IV. Amendments to the Drawings

Fig. 1

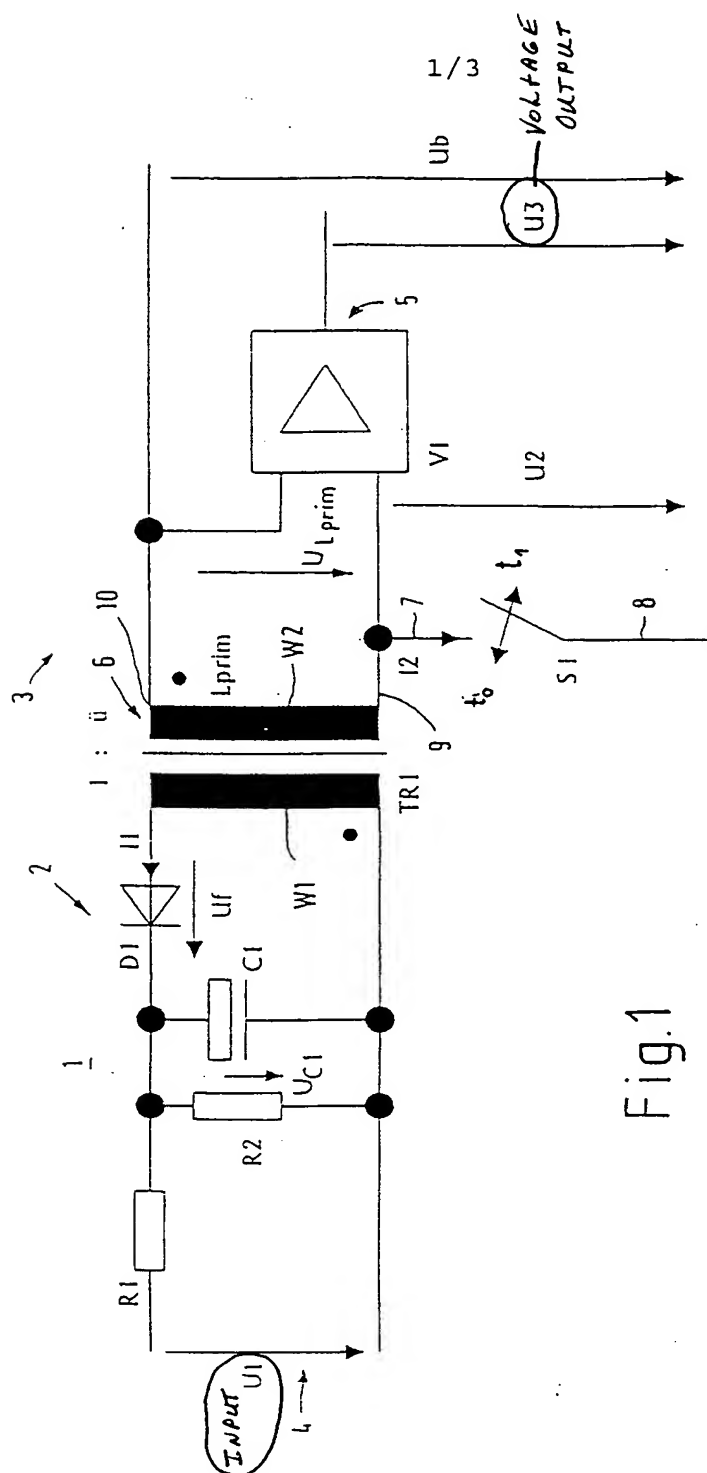
Applicant has submitted a replacement drawing sheet, drawing sheet #1, which includes amended Figure 1. Figure 1 has been amended to add the wording "Input" at U1 and "Voltage Output" at U3.
